Transport Rebuttal of Proof of Evidence

Application 21/01028/OUTMAJ

HMP Garth and HMP Wymott, Moss Lane, Ulnes Walton, Leyland

Rebuttal of Proof of Evidence of Kevin Riley, Lynette Morrissey, Paul Parker and Emma Curtis

Figure 2-1 – Nearby Post Boxes

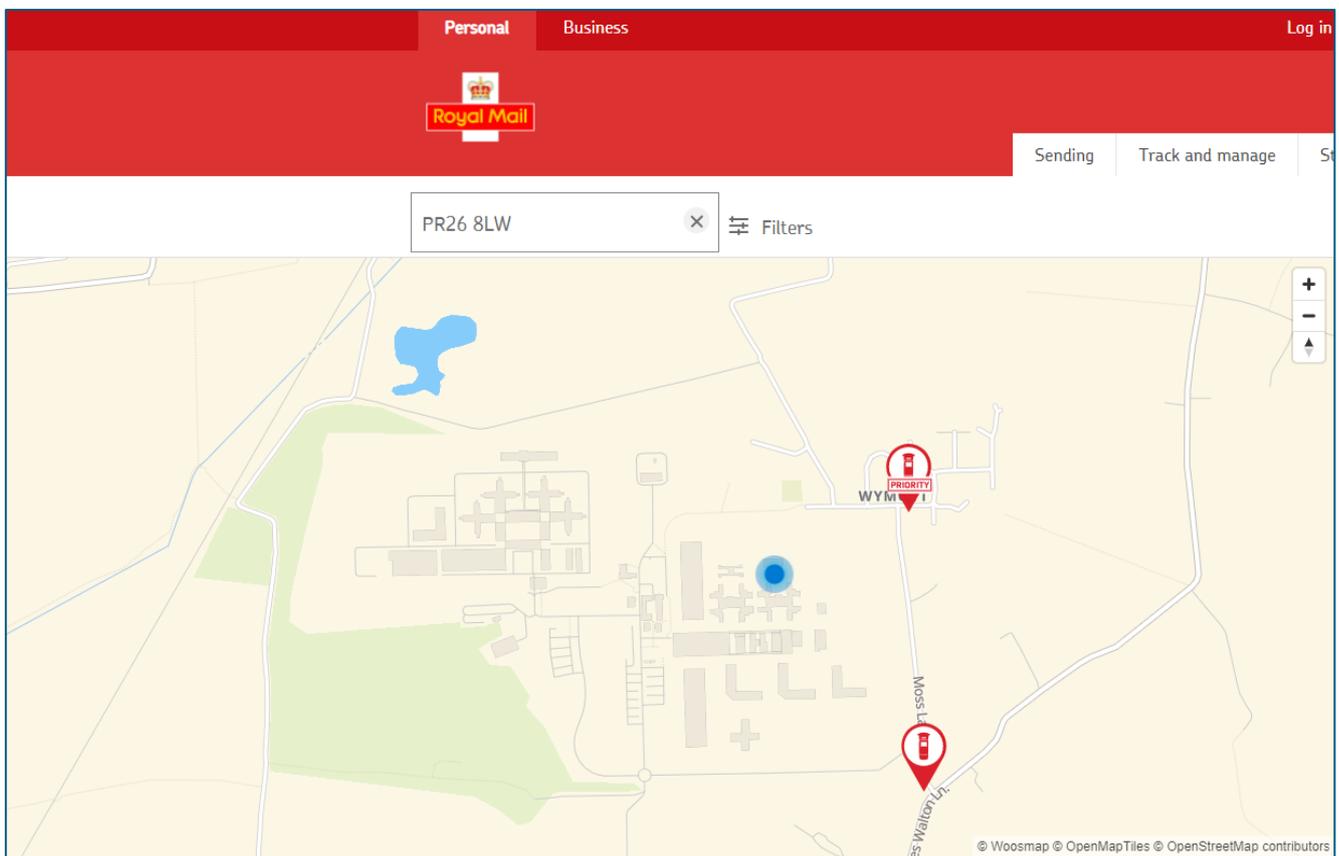
2.5.1. Paragraph 6.2.6 states that “the proposals do not mitigate the impact on users to the post box at the junction of Moss Lane/Ulnes Walton Lane, which is also an important local service for residents at the north of Moss Lane”.

2.5.2. Mr Riley has not recognised that there is an existing post box located within Wymott Village (on Willow Road) which is more convenient for residents and Royal Mail has identified it as a ‘Priority’ post box³. Figure 2-1 outlines the location of the post boxes located close to GW2.

Figure 2-2 – LCC PRow Map

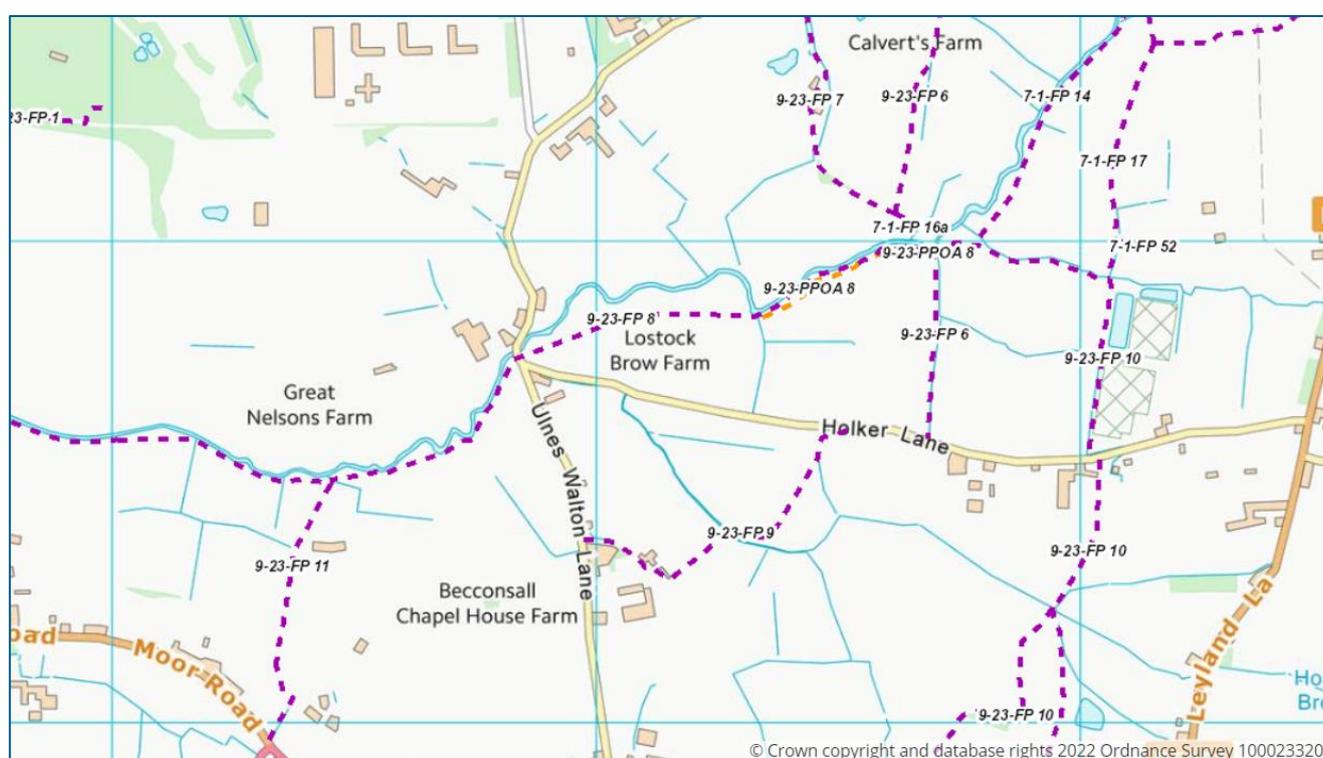
- 2.6.1. Paragraph 6.2.11 states that the “increase in traffic of 24% on Ulmes Walton Lane south of Moss Lane will also impact on PRow routes FP9 and FP8. The combined lack of formal crossing facilities at these locations and the forecast increases in traffic will expose PRow users to a greater number of vehicles and will increase waiting time to cross the road. This often leads to impatience and risk-taking behaviour, ultimately increasing the risk of accidents”.
- 2.6.2. For context, Figure 2-2 provides an extract from Lancashire County Council’s online interactive PRow map⁴. It outlines the location of FP9 and FP8 which Mr Riley refers to within his PoE.

- 2.6.3. Mr Riley’s Proof has not included any evidence to quantify the demand for PRow routes FP9 or FP8; neither has Mr Riley included any analysis to demonstrate that the existing crossing situation would not be appropriate once GW2 is constructed.
- 2.6.4. DMRB TA 52/87 was the predecessor of the current LTN 1/95 guidance. Whilst I acknowledge that TA 52/87 has been withdrawn, it outlined the threshold values for a PV² assessment which provides a proxy for the number of PRow users required per hour to justify a formal pedestrian crossing (where V is the two-way hourly flow of vehicles and P is the number of pedestrians crossing 50m either side of the site).
- 2.6.5. Figure 2-3 (overleaf) outlines the PV² thresholds contained within TA 52/87.

Site A5 Transport Appraisal

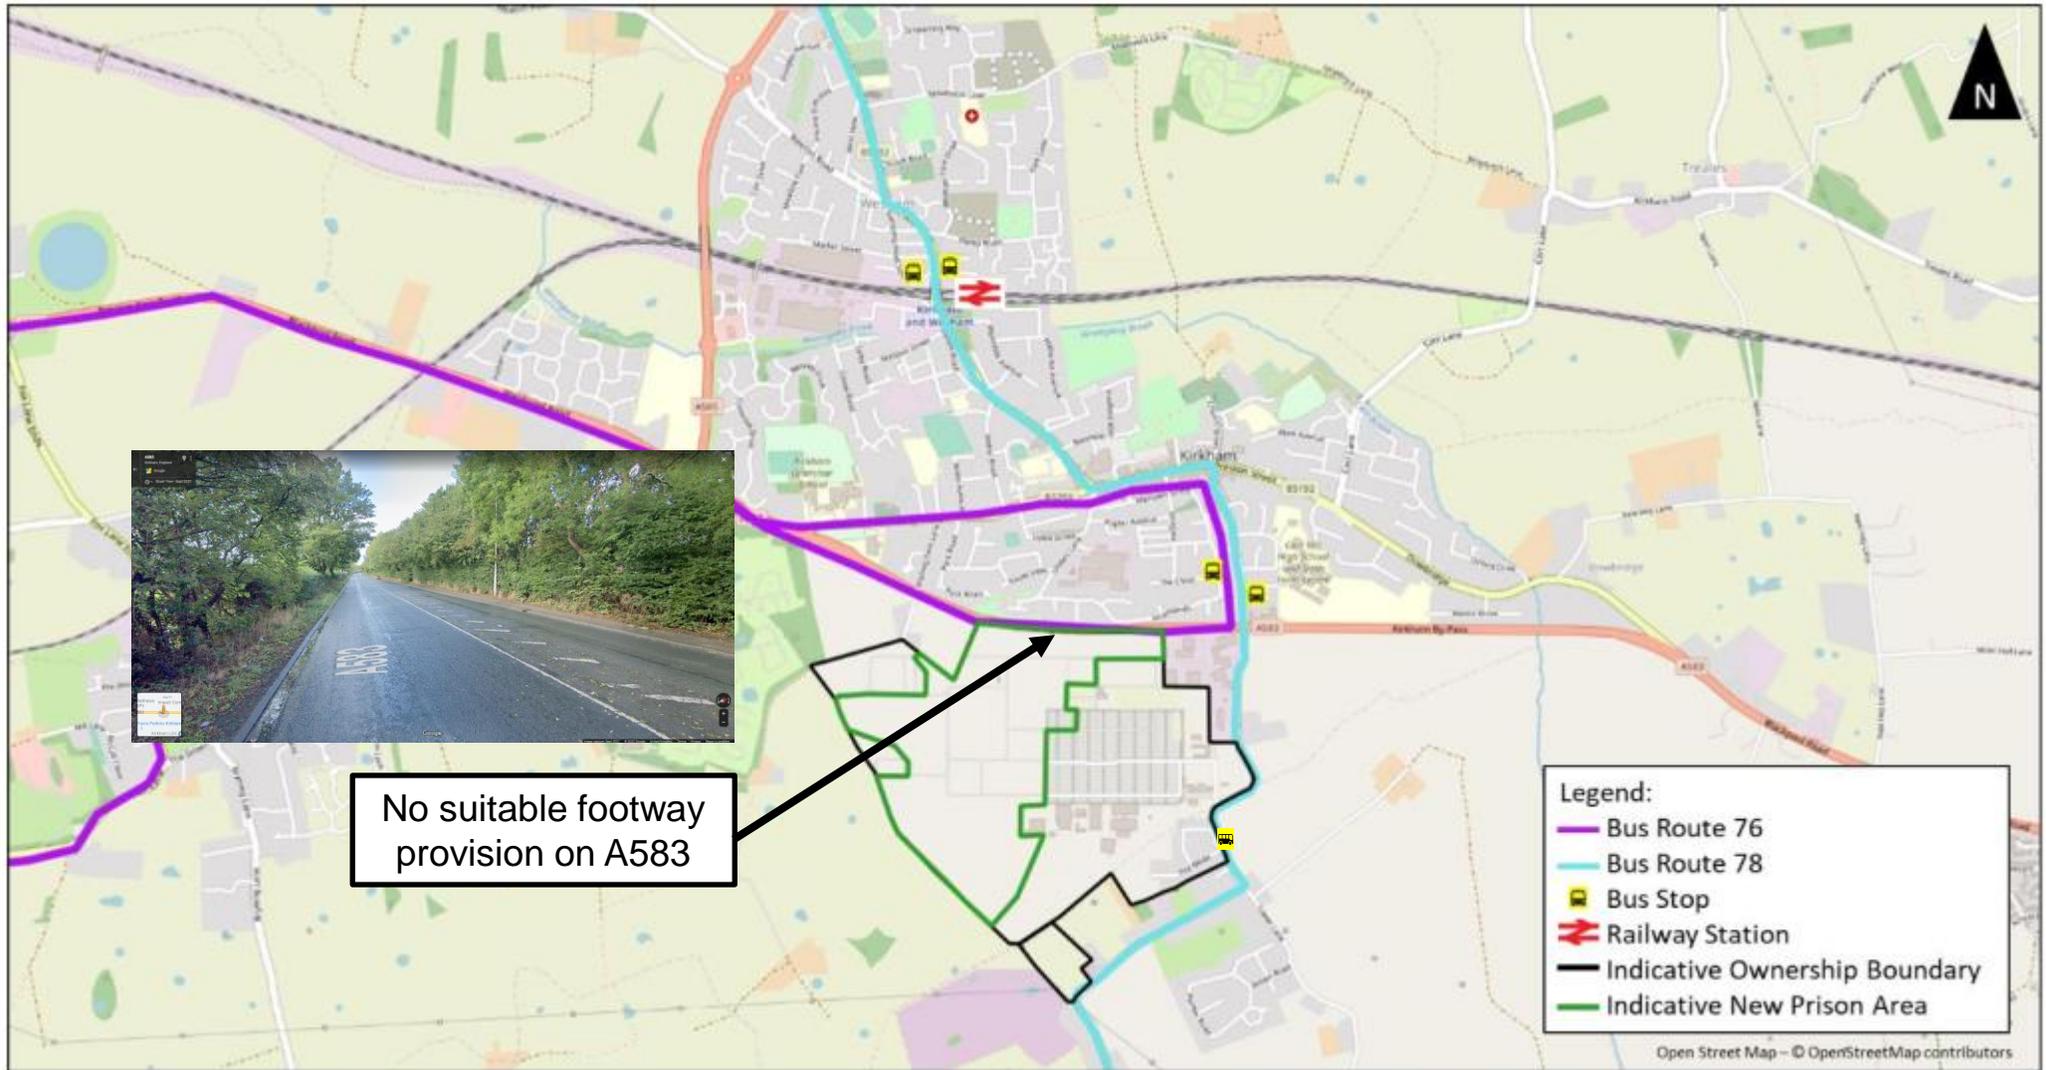
- 5.1.1. Mr Parker has provided an assessment of two alternative sites, A5 and A6, and he has included this assessment in his Appendix 3 (Core Document G4c). Within G4c Mr Parker has assessed two transport related criteria; “Have a good strategic access to public transport and motorway/trunk road network” and “Accessible for construction without major enhancement of transport infrastructure”
- 5.1.2. I have provided a review of these assessments, included in Appendix B of this rebuttal. My opinion is that A5 performs relatively poorly from a transport perspective, and that A6 and the Appeal site are comparable. Ms Hulse, within her Proof (Core Document E2) and Rebuttal provides further comment on alternative sites and assessment criteria.

Existing buildings prohibit access to Touchet Hall Road and associated bus services (no.17)
